Sheet: /Clock\_and\_address/

**Title: Lomas Color Magic Redux**

Rev: 1.1-004

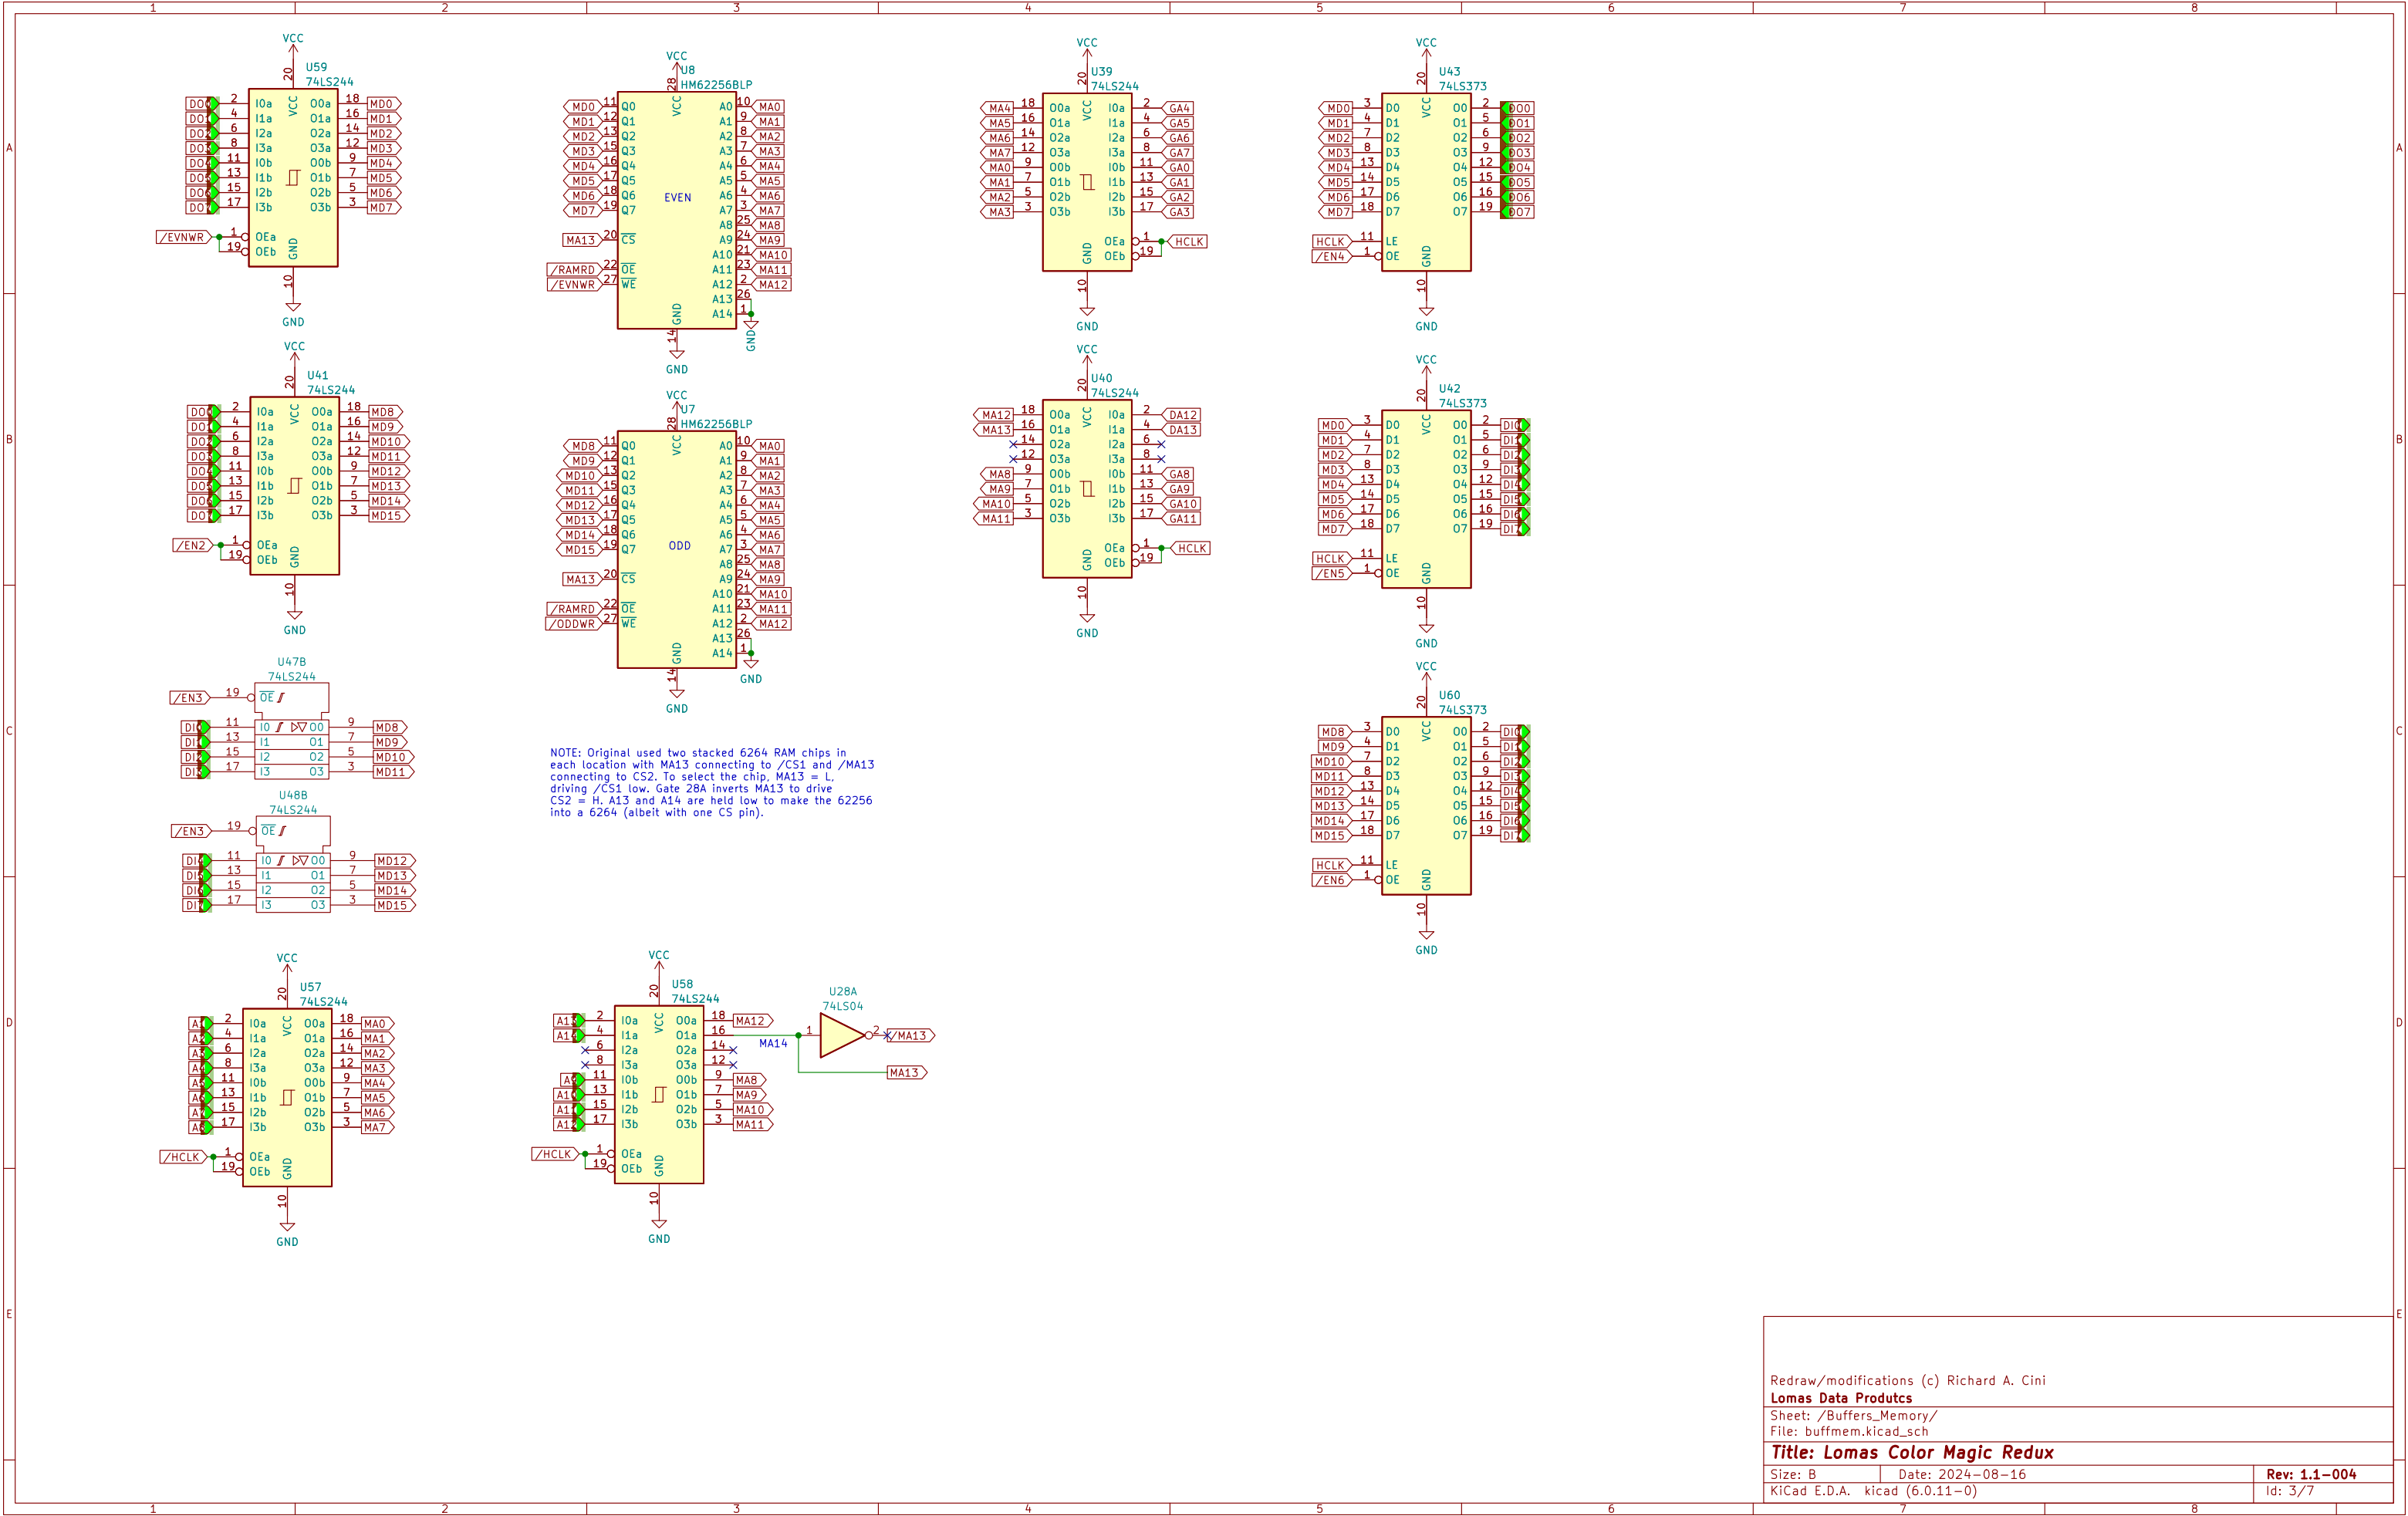
C	<div>ERRATA from 1.0 to 1.1-002:</div> <div>00. v1.0 of board was trashed.</div> <div>01. Resistor footprints are one size too small -- 1/4w uses 1/8w, etc. Due to space limitations, left at 1/8w.</div> <div>02. U49/78L12 silkscreen is backwards. Corrected.</div> <div>03. Several chips have unconnected VCC or GND leads that might be from the use of ONE and ZERO. Corrected.</div> <div>ERRATA from 1.1-002 to 1.1-003</div> <div>v.003 was never manufactured.</div> <div>ERRATA from 1.1-003 to 1.1-004</div> <div>01. J6 (address select) is flipped. Rotated 180.</div> <div>02. Design relies on SLAVE_CLR [54] for reset, but not all boards (like the SCP 200B) generate that signal. Reused spare gate of the LS125 and added a jumper and pull-up to generate that signal driven by POC [99].</div> <div>03. Changed memory chip wiring to be similar to the original, using MA13 as the CS* and grounding A13 and A14 of the 62256 (thus making it a 6264 albeit with only one chip select).</div> <div>04. Discovered that A6 is connected twice on U55. Changed second to A5.</div> <div>The 1.1-004 version works.</div>					C

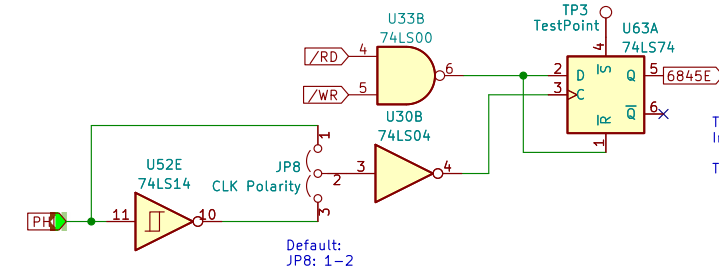
NOTE: R7/R8 was specified as 1.0kQ on schematic but 470Q was used in the actual manufacturing of the board. Prior to converting to a TTL oscillator, 1.0kQ was determined to work better. Also, install a jumper in place of C8. This should result in a frequency of ~14.305MHz.

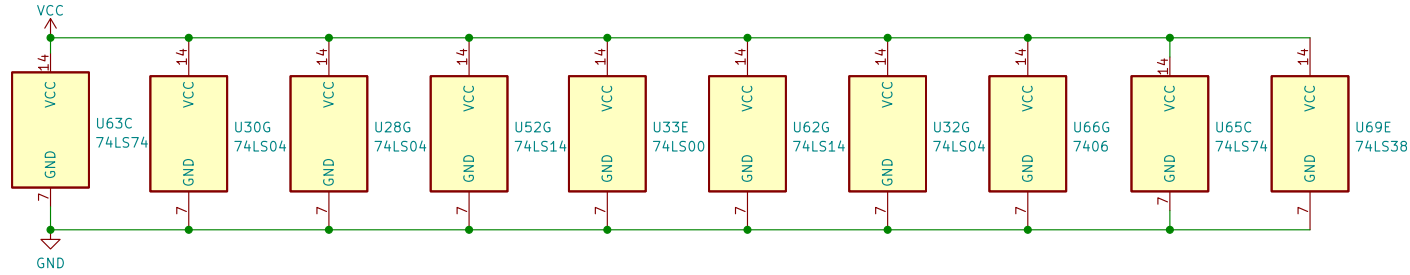
TP3: On the prototype U63.4 is left floating. In the IBM CGA adapter, it's tied to Vcc.  
TIE TO VCC

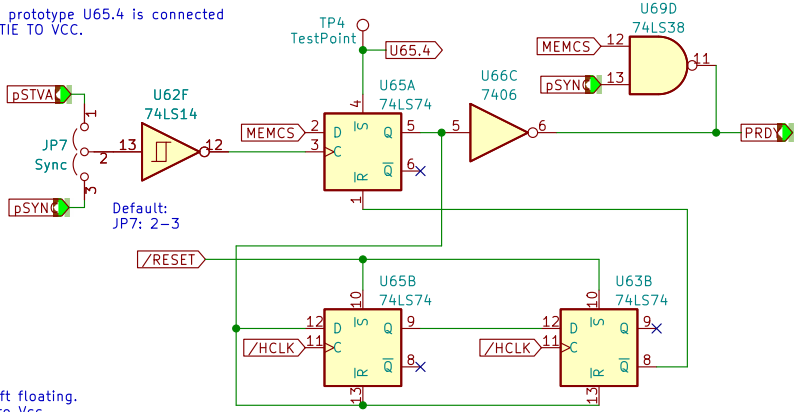
TP4: On the prototype U65.4 is connected to U64.10. TIE TO VCC.

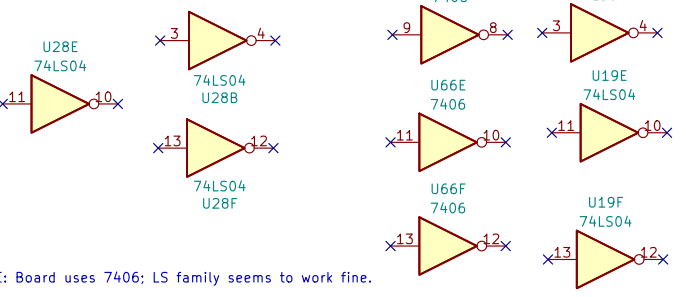
NOTE: Board uses 7406; LS family seems to work fine.

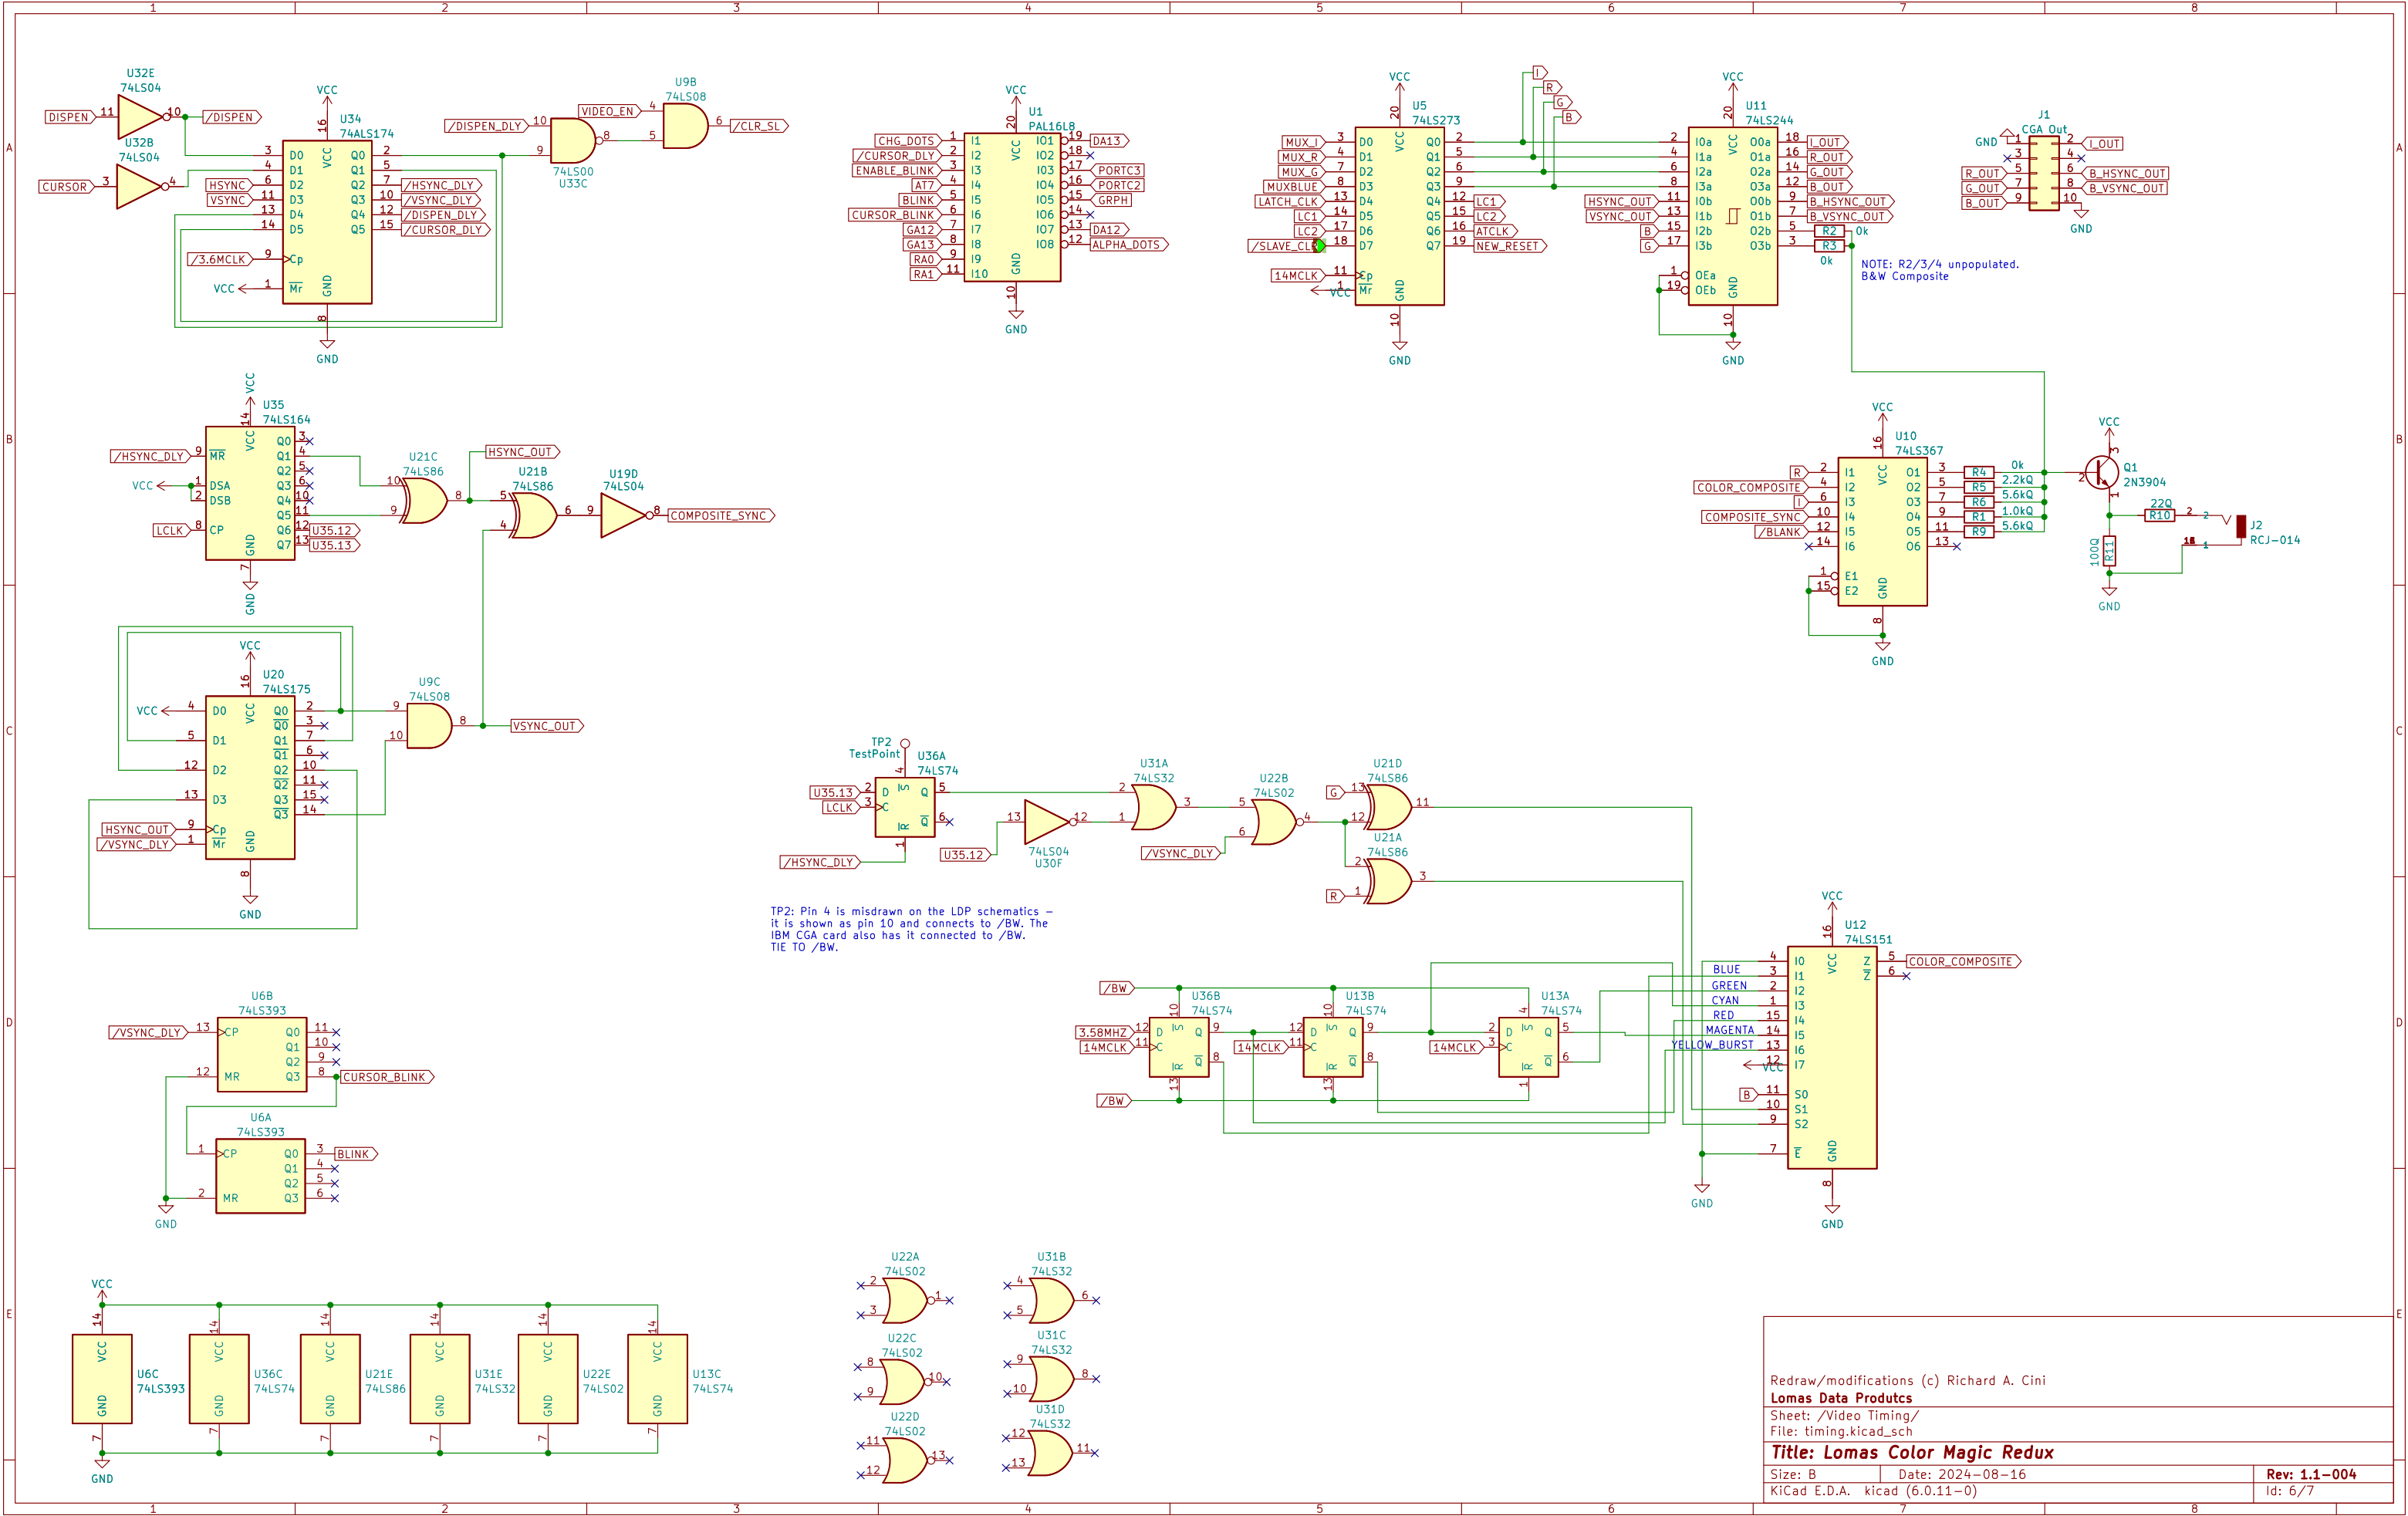
TP2: Pin 4 is misdrawn on the LDP schematics – it is shown as pin 10 and connects to /BW. The IBM CGA card also has it connected to /BW. TIE TO /BW.
